Agenda
City of Springboro Planning Commission Meeting
Wednesday, February 14, 2024, 6:00 p.m.
Council Chambers, City Building, 320 West Central Avenue

General Plan, 6821 Red Lion-Five Points Road, Bailey Farms PUD-R, Planned Unit Development-Residential, single-family residential development

City staff recommends approval of the general plan for the Bailey Farms PUD-R, Planned Unit Development-Residential, located at 6821 Red Lion-Five Points Road, contingent on the following comments:

BAILEY FARM CONCEPT
 CITY OF SPRINGBORO
 GENERAL PLAN

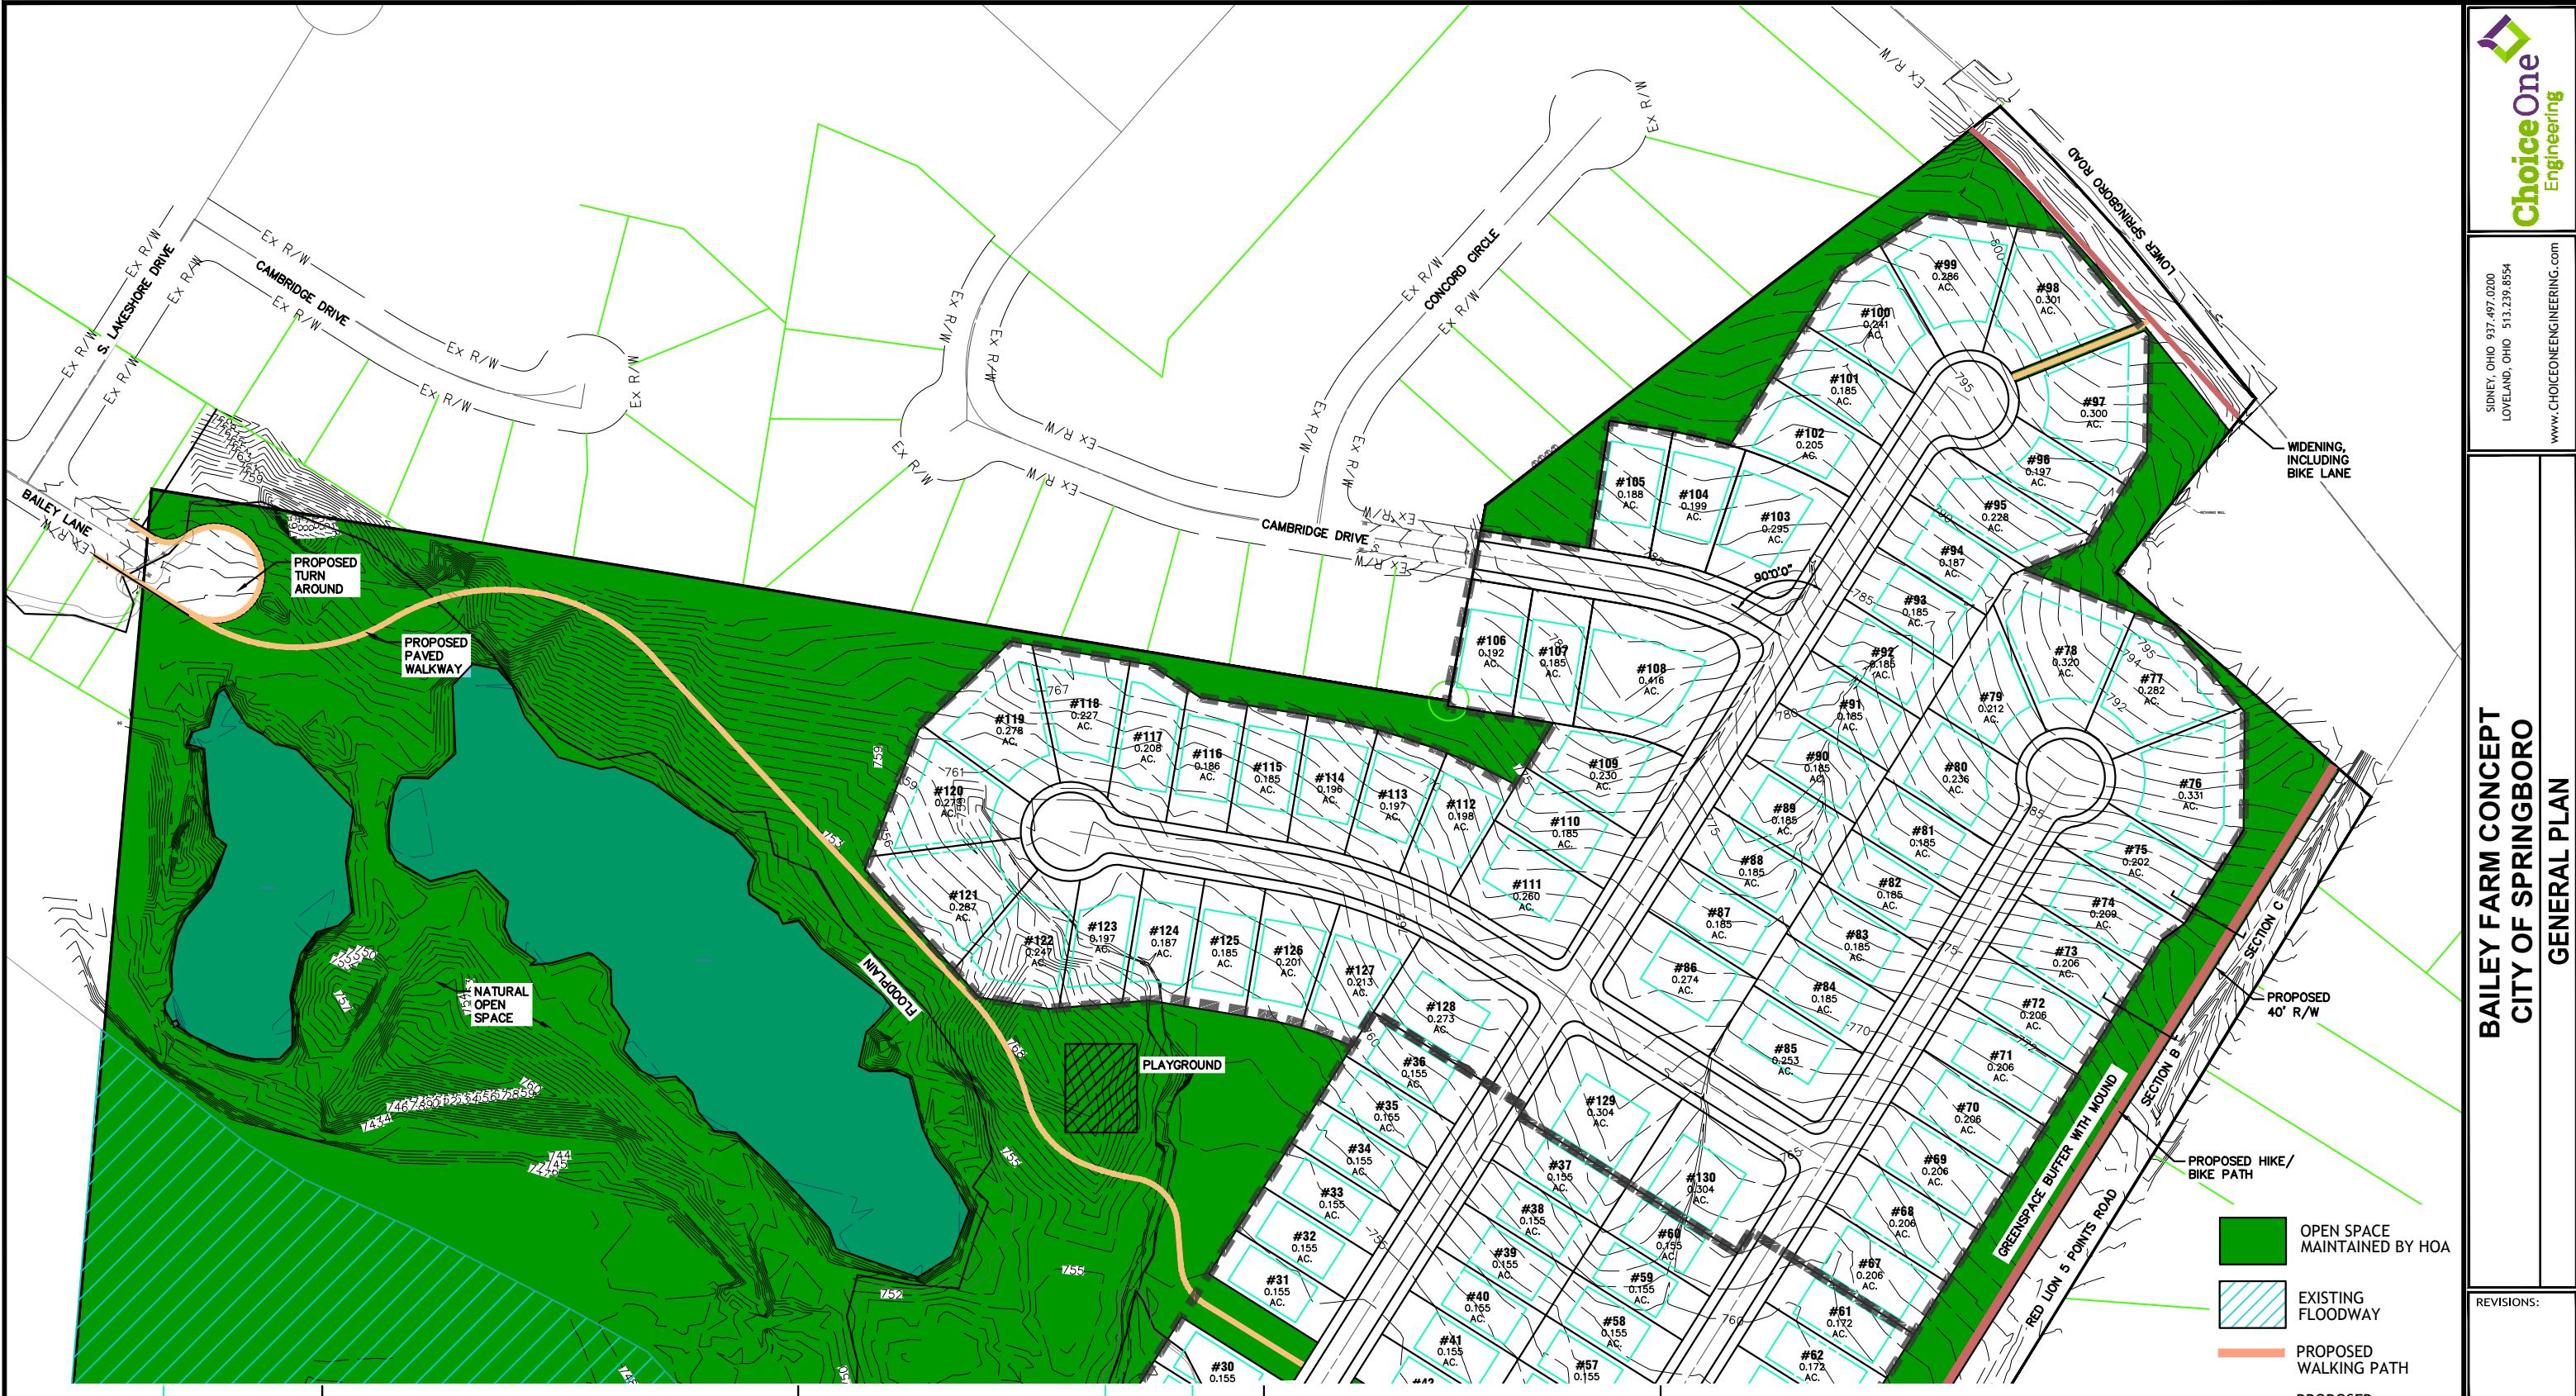
1. Setbacks are measured at the overhang.
2. Roadway improvements along Lower Springboro Road to include: dedicate 40 feet half right of way, widen the road to 18 feet from center line of road to south, add curb & gutter, storm sewer, sidewalk/bike lane.

3. Provide relief sewer and remove the existing lift station in the Villages of Creekside. Provide water main stub into the golf course along the proposed cul-de-sac at the east end of Bailey Lane. Water main shall be looped with Villages of Creekside and The Fairways subdivisions. Details to be worked out on construction drawings.

4. No development is to occur in the floodway and or floodplain, without prior permit approval by the City Engineer.
5. Provide locations of detention/retention storm water facilities.

6. Roadway and utility improvements shall be per city specifications.
7. Revise General Plan drawings to have standard engineering scale type on each sheet, i.e. 1"=20', 30', 40', 50', 60', 100', 200'. Print sheets to scale.

8. Details regarding the improvements along Red-Lion Five Points Road to meet requirements of Warren County/Clearcreek Township and meet the requirements of the previous annexation of the property, specifically: When the subject property is proposed to be developed, the owner will, as part of its Record Plat establish a fifty foot (50') wide buffer strip along the west side of Red Lion-Five Points Road, to be owned and maintained by the homeowners' association for the subdivision. With the filing of such record plat, the owner shall also guarantee the construction of an attractively-contoured seven foot (7') high, minimum, landscaped mound within the buffer strip, with side slopes not to exceed a grade of 3:1. The minimum height of the mound shall be measured from the existing grade of the adjoining pavement on Red Lion-Five Points Road. The buffer strip may be reduced in width to no less than 40' where the side of the mound away from Red Lion-Five Points Road is terminated into a decorative stone retaining wall. The retaining wall need not follow the lot line provided that it is entirely within the buffer strip. In such event, the adjacent building lot may extend to that retaining wall. Included in the landscaping of the buffer strip shall be trees of appropriate species. Evergreen trees shall be at least 5' tall and deciduous trees shall be at least 1-1/2" caliper at the time of planting. Provide cross section of buffer and paved trail, along Red Lion Five Points Road, to confirm that 50' green space buffer is wide enough to meet requirements stated above. If not, revise accordingly.

9. Basements shall be served by gravity sewer and shall not be permitted otherwise. Grinder pumps are not permitted.
10. Details for proposed common areas to be provided during final development plan, stage 2 of PUD approval process.

11. Only 19 lots are permitted to be platted prior to second entrance.
12. Post lights shall be located on each lot, controlled by a photoelectric cell, and shall be operable at all times.
